7. Dawn Estates Whittenberg Addition; KPB File 2024-120 Edge Survey & Design, LLC / Whittenberg Location: Edgington Road & Ryan Lane Sterling Area

ITEM #7 - PRELIMINARY PLAT DAWN ESTATES WHITTENBERG ADDITION

KPB File No.	2024-120				
Plat Committee Meeting:	November 18, 2024				
Applicant / Owner:	Robert and Betty Whittenberg of Soldotna, Alaska				
Surveyor:	Jason Young – Edge Surveying and Design, LLC				
General Location:	Sterling

KPB 2024-120

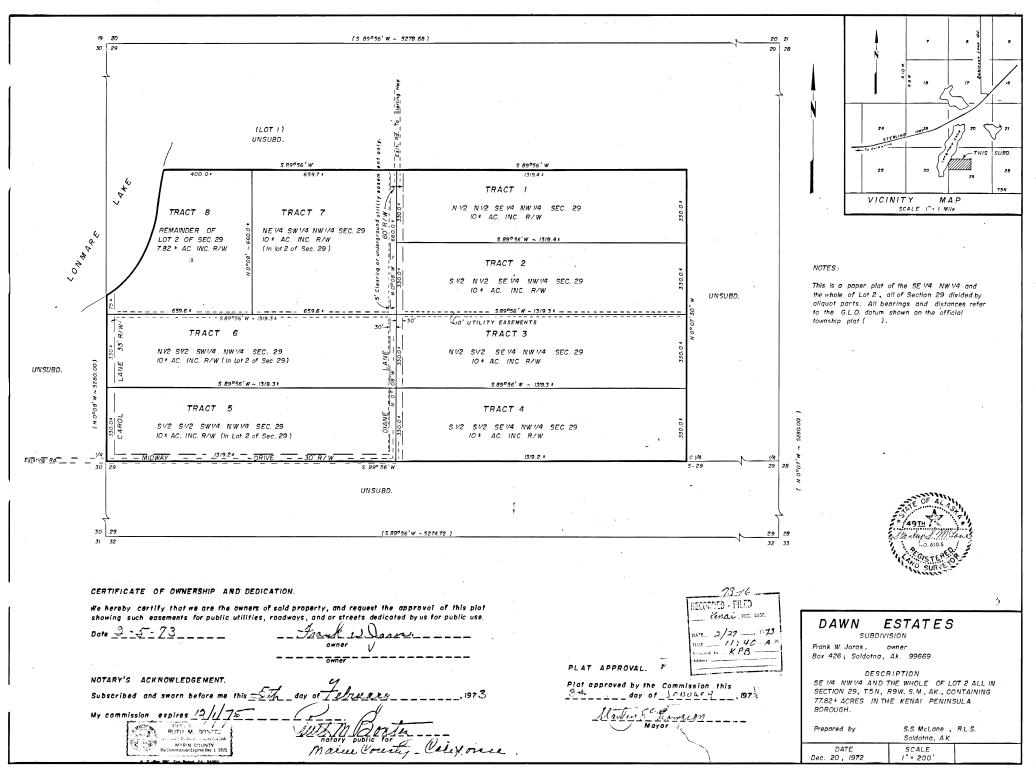
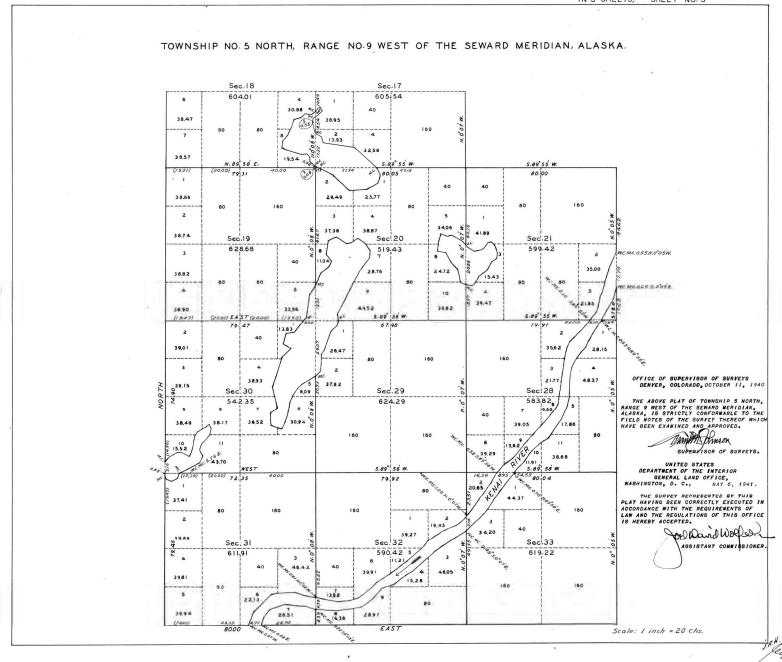
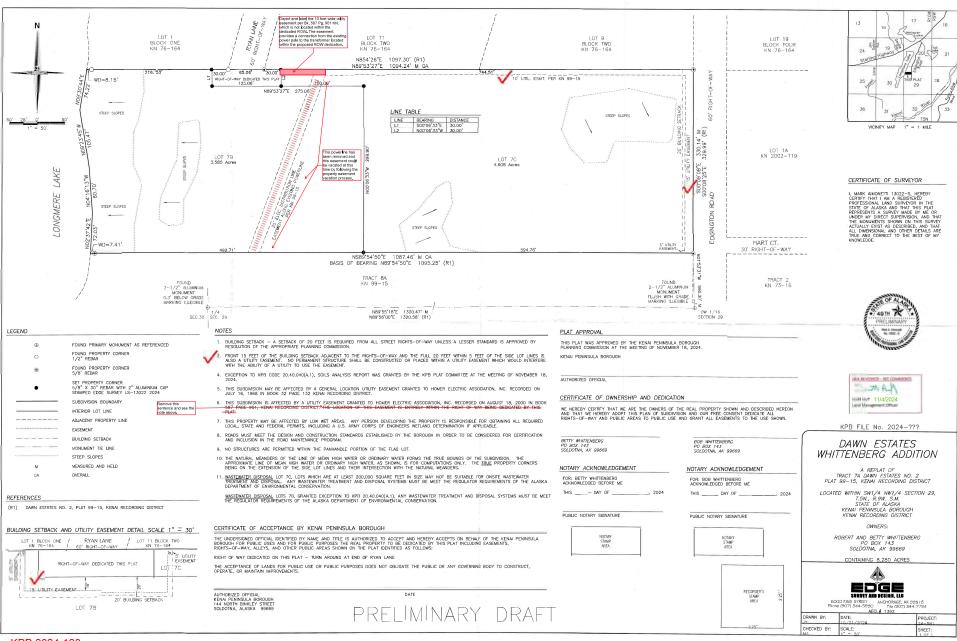
Staff recommendation: Include middle initial to owner's name: Robert L Whittenberg to match the CTP Revise the KPB File no to 2024-120

- Staff recommendation: Move the locations of the ranges to correct location
- E. All parcels of land including those intended for private ownership and those to be dedicated for public use or reserved in the deeds for the use of all property owners in the proposed subdivision, together with the purposes, conditions, or limitations of reservations that could affect the subdivision;

- **Staff recommendation:** Add plat note referencing CCR's per CTP # 11.
- F. The location, width and name of existing and platted streets and public ways, railroad rights-of-way, easements, and travel ways existing and proposed, within the subdivision;

- **Staff recommendation:** Label and depict HEA easement per CTP # 11. Modify plat note number 5 to exclude easement being within ROW dedication. See HEA's comment.

- The utility easement adjacent to Edgington Road was granted by plat KN 99-15 as a 10-foot utility easement. Change easement width if want to down to 10'

Staff recommendation: Correct parcel to the north on plat and plat detail: Lot 1, Block 2, KN 76-164. Correct parcel to east: Lot 10. Block 4. KN 76-164.

Staff recommendation: Possible shed encroachment from Lot 1
